Docket Item # 3  
BZA Case #2017-0036  
Board of Zoning Appeals  
January 11, 2018

**ADDRESS:** 1210 TRINITY DRIVE  
**ZONE:** R-12/RESIDENTIAL SINGLE-FAMILY  
**APPLICANT:** SW TRINITY DEVELOPMENT LLC, BY STEVE KULINSKI,  
ARCHITECT

**ISSUE:** Variance request to construct a single-family dwelling behind the required established average setback.

ATTACHMENT #1: TREE PRESERVATION AREA

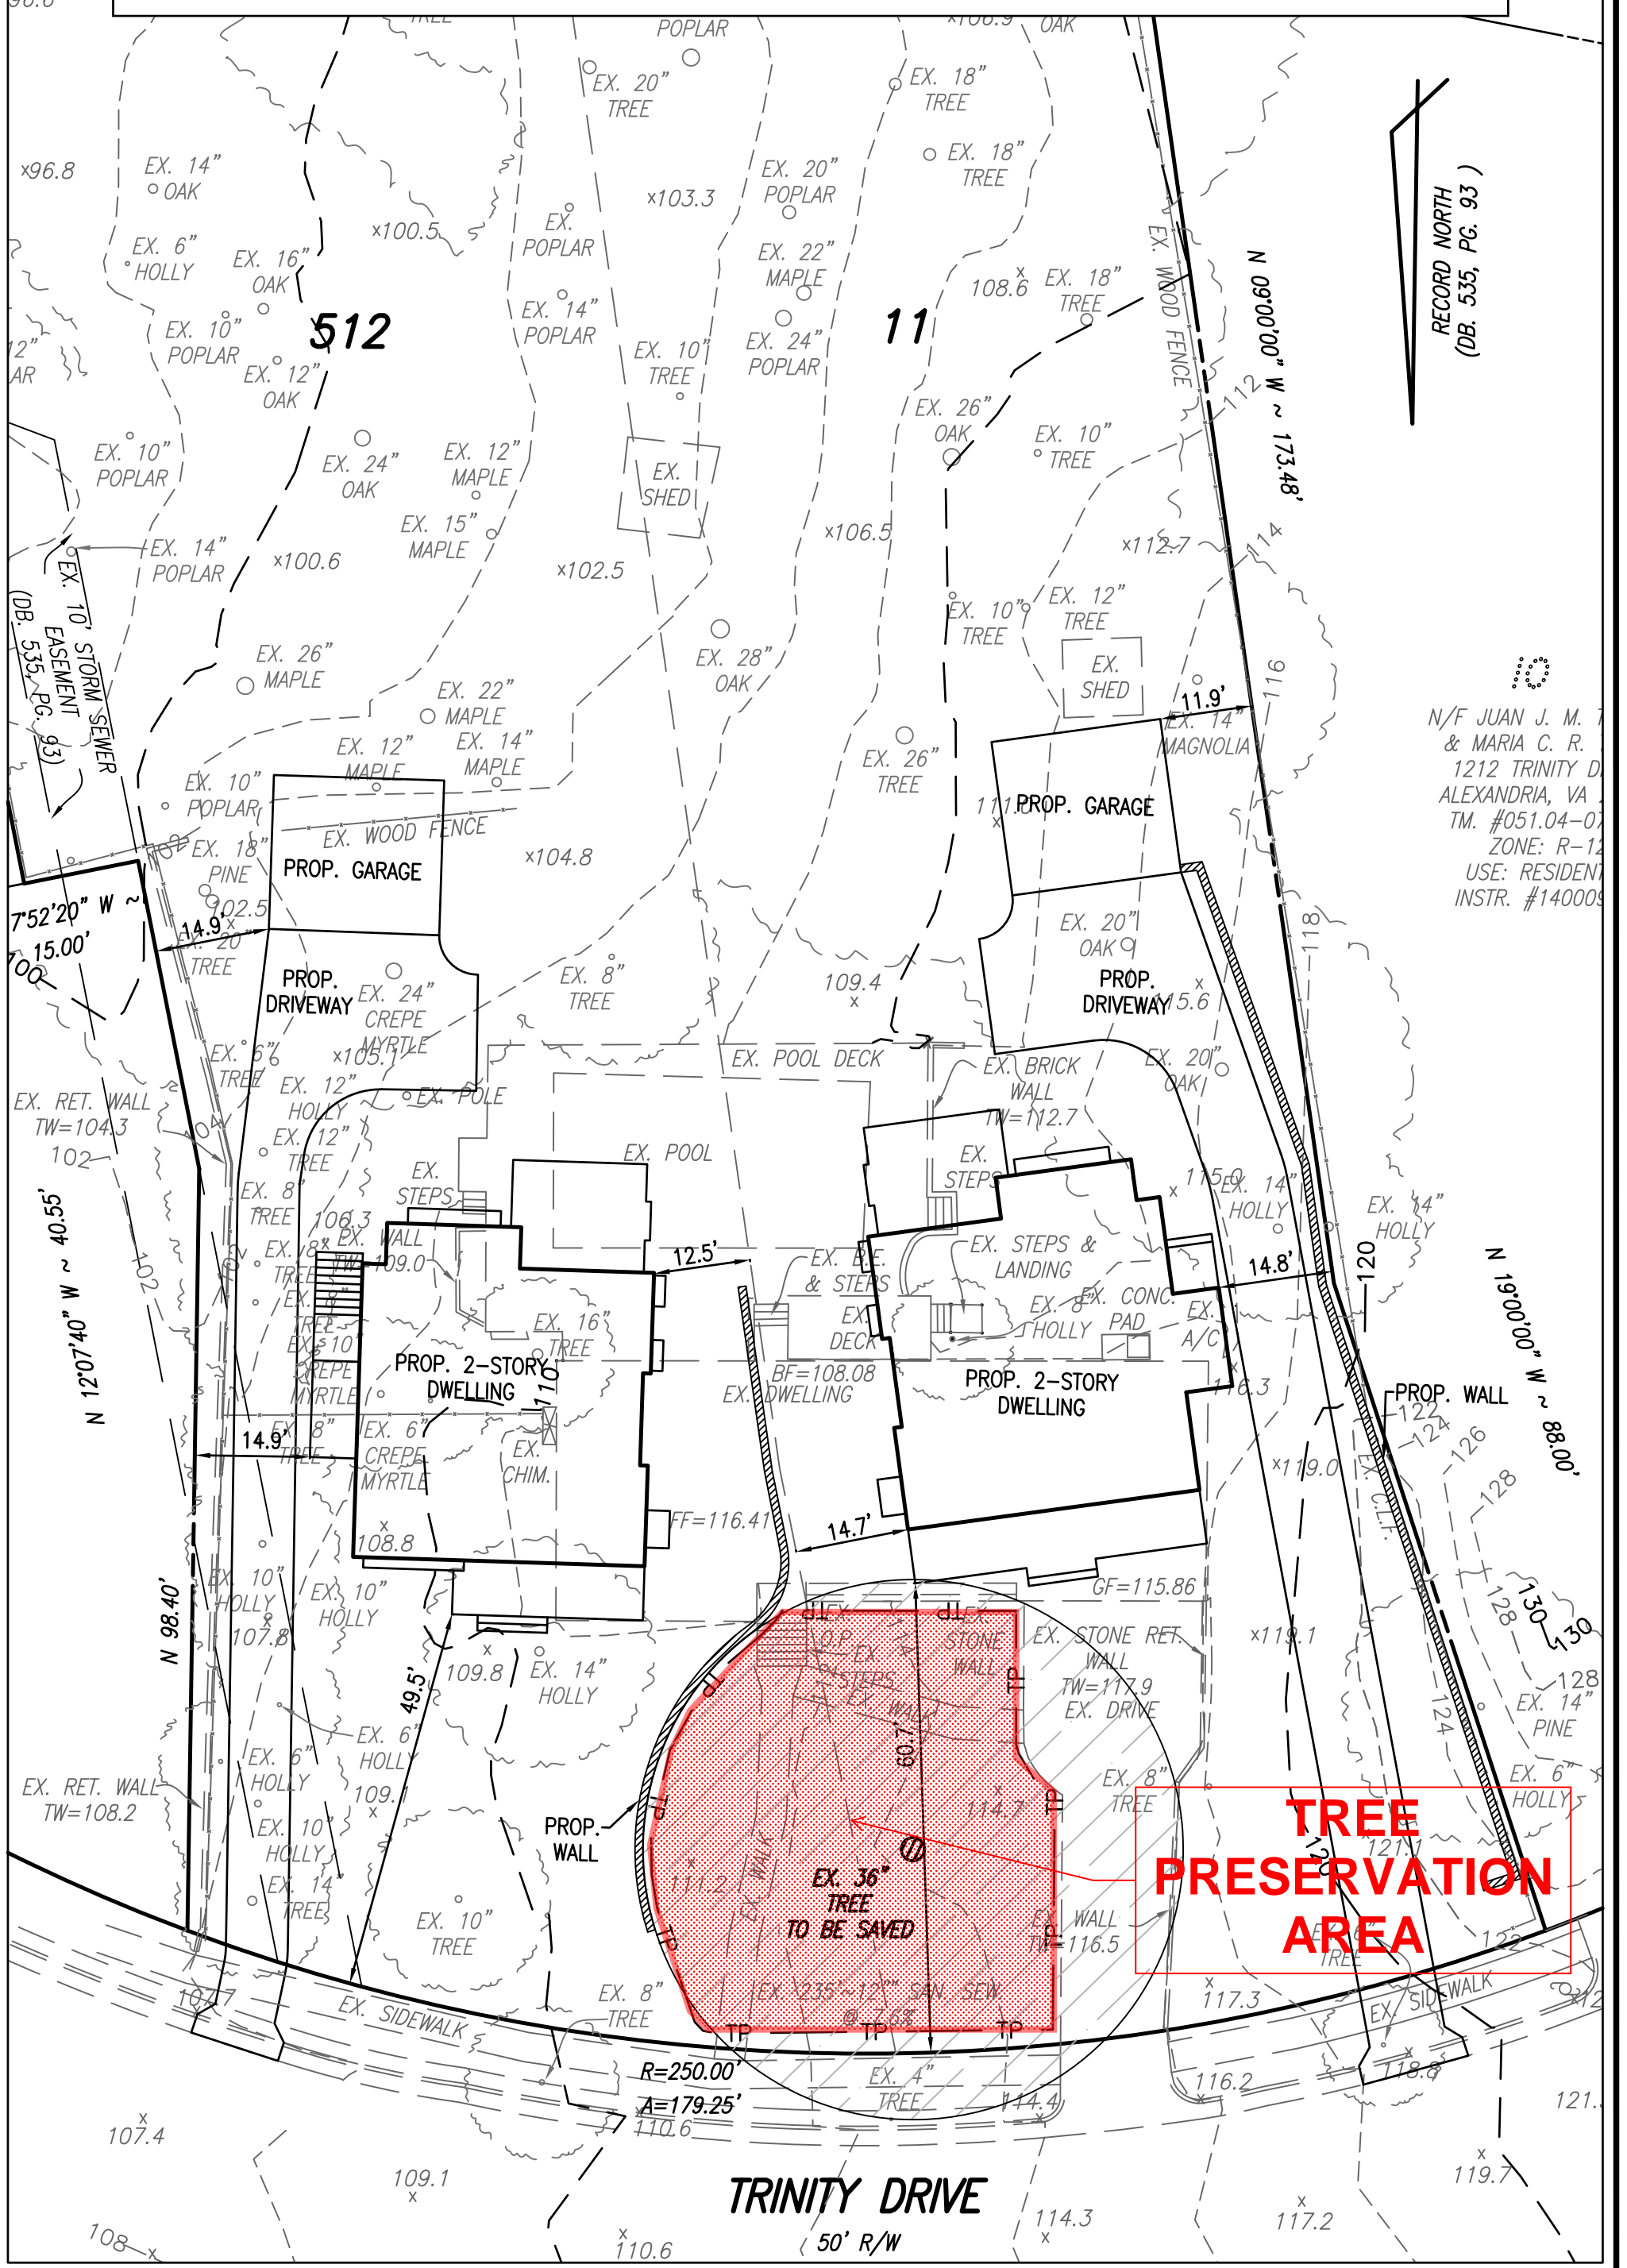
- F-1 I have reviewed the proposed variance , and I support its approval in order to preserve the mature willow oak tree located in the front yard of the property. The tree is approximately 47" tree, and is one of the largest willow oak trees in the City. The tree benefits the City and the neighborhood by providing canopy cover, intercepting storm water, carbon and pollutant sequestration and pollution. The survival of the tree will be dependent upon providing as much room as possible maximize the undisturbed area of root disturbance during the construction of the proposed houses. The tree preservation zone shown in the provided plans should be adequate provide there will be no construction related activities throughout the construction process. This means that no utilities, i.e. water, sanitary, electric, etc. may be installed underground in the preservation area.

As outlined above, staff **recommends approval** of the request with the condition that the tree preservation area shown on attachment one of this report shall be maintained throughout construction.

# VARIANCE PLAT

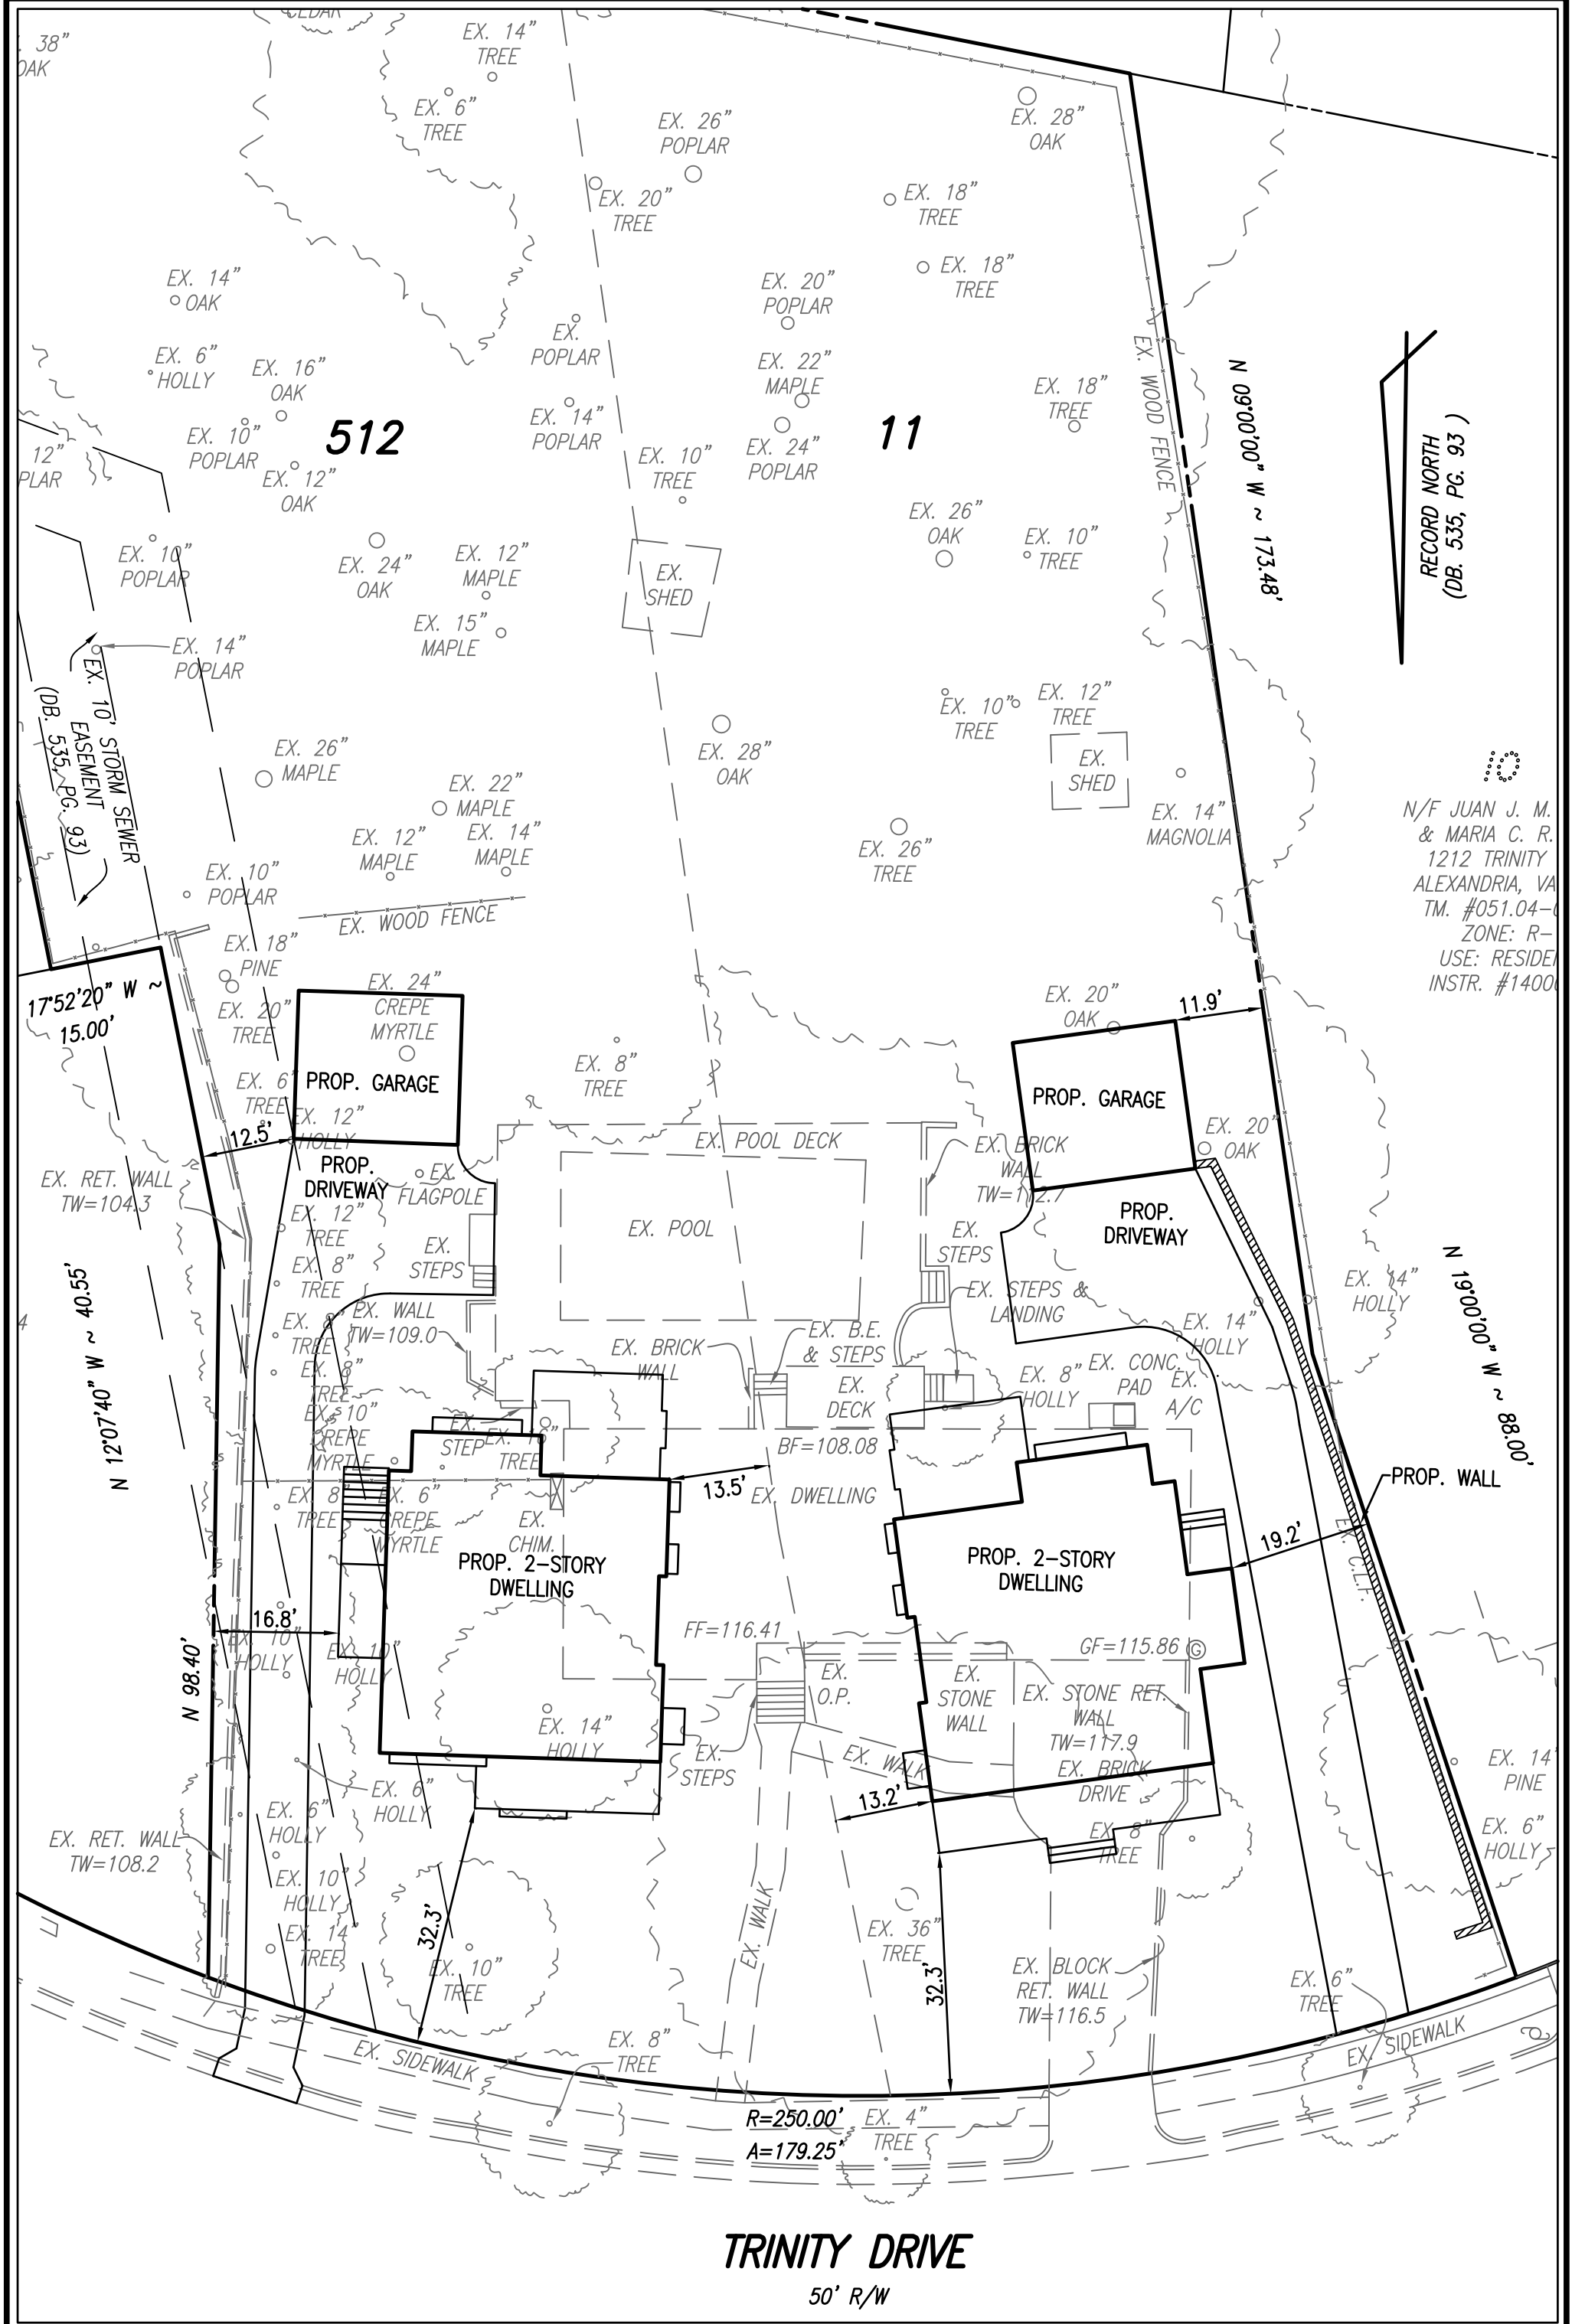
The applicants propose to demolish the existing dwelling and construct a new single-family, two-story dwelling with front porch and detached garage. The proposed dwelling would be located 60.70 feet from the front property line. The required front setback is 31.70 feet based on the average of the established front setbacks of houses on the south side of Trinity Drive between Canterbury Lane and Princeton Boulevard. The applicants request a variance of 29.00 feet from the required front setback.

The required front setback is 31.70 feet based on the average of the established front setbacks of houses on the south side of Trinity Drive between Canterbury Lane and Princeton Boulevard. The applicants propose to construct the dwelling 60.70 feet from the front property line. The applicants request a variance of 29.00 feet from the 31.70 feet required front setback line to preserve a large willow oak tree.

**The applicants request a deviation of 29.00 feet beyond the required front setback. As compared to other properties' front yards within the immediate blockface, the subject property's front yard is deeper because of the curvilinear front property line. The visual impact of the requested deviation requested would be noticeably reduced by the additional depth of the front yard. Because of this, the proposed dwelling, despite being located ~~17.80~~29.00 feet behind the required front setback, would appear in line with other dwellings within the immediate blockface. One of Section 7-2503(A)'s purposes is to increase compatibility of new dwellings with an existing blockface. Because the appearance of a uniform blockface would not be affected, the requested deviation is reasonable.**

**Strict application of zoning ordinance section 7-2503(A) would require any new residential dwelling on this lot to be constructed within the preservation area of the willow oak tree; necessitating its removal. A dwelling that complies with the required front setback could not be constructed on the lot without removing the tree. As such, strict application of section 7-2503(A) unreasonably restricts the utilization of the subject property because it cannot be used as a new single-family dwelling without also requiring the removal of the large willow oak tree.**

Staff **recommends approval** of the request because it meets the variance definition and standards. If the Board approves the request, staff recommends that the tree preservation area shown on attachment one of this report shall be maintained throughout construction.
